BUILDING CODE OF AUSTRALIA (BCA) COMPLIANCE

ASSESSMENT REPORT

Project Address	2 DELMAR PARADE DEE WHY, NSW 2099
Report No.	19/055
Prepared for	LANDMARK GROUP
Report by	BEN LEEDHAM
Title/Company	DIRECTOR / ARAMINI + LEEDHAM CONSULTING PTY LTD
Date	25 JUNE 2020

Level one

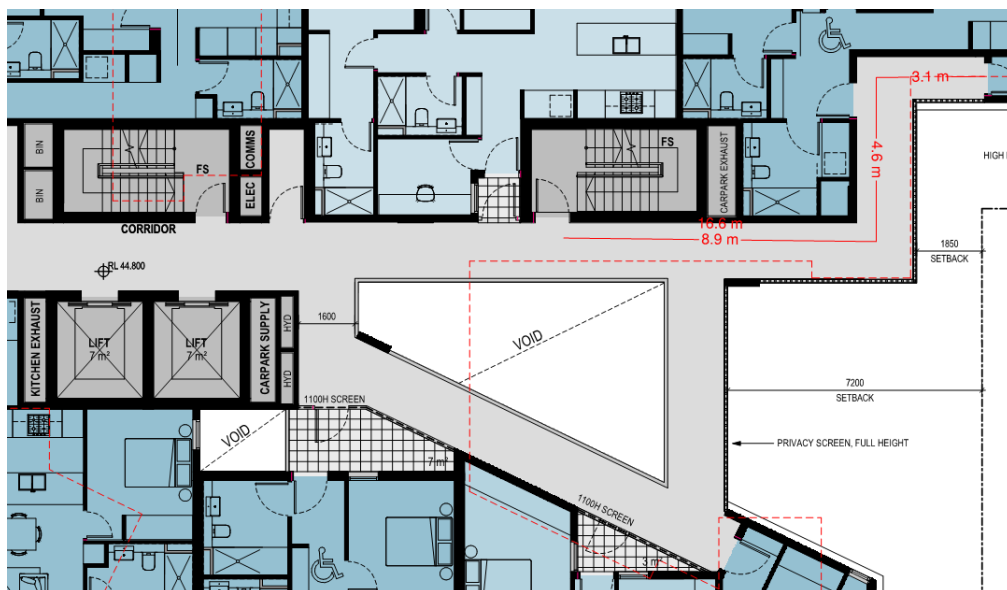
- Travel distances to a point of choice between the two exits provided well exceeds the maximum permissible 6m distance. Some units are required to travel up to 25m to the point of choice, which still exceeds the 12m limit if the permitted concession applies under Specification E1.5a Clause 3
- Travel distances from the communal courtyard to the closest exit also well exceeds the maximum permissible 20m

Level two & three

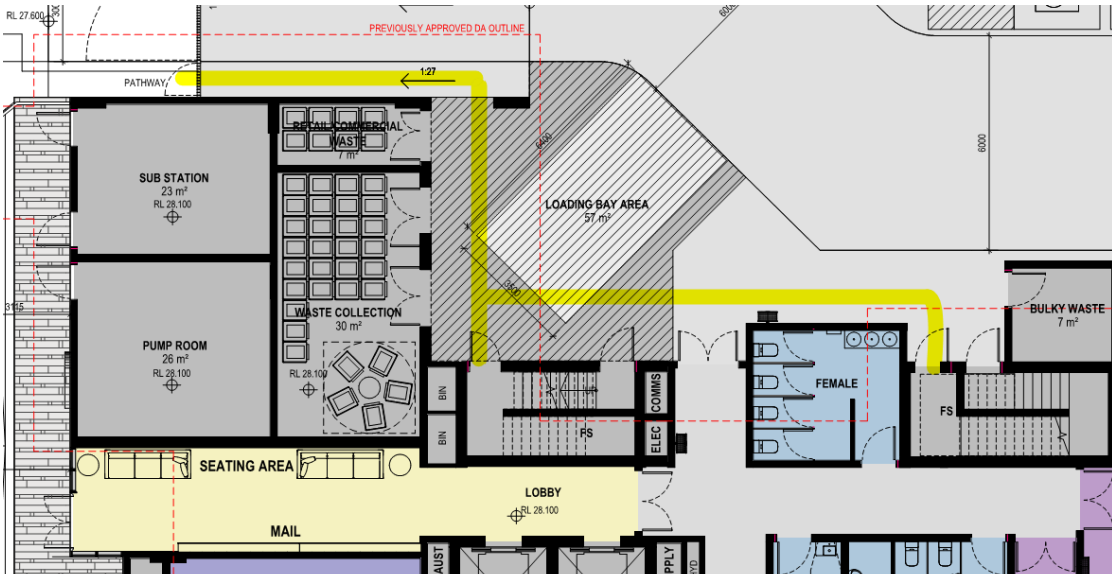
- Travel distances to a point of choice between the two exits provided exceed the maximum permissible 6m distance. Even if concession applies under Specification E1.5a Clause 3, the 12m limit is still exceeded to a point of choice.
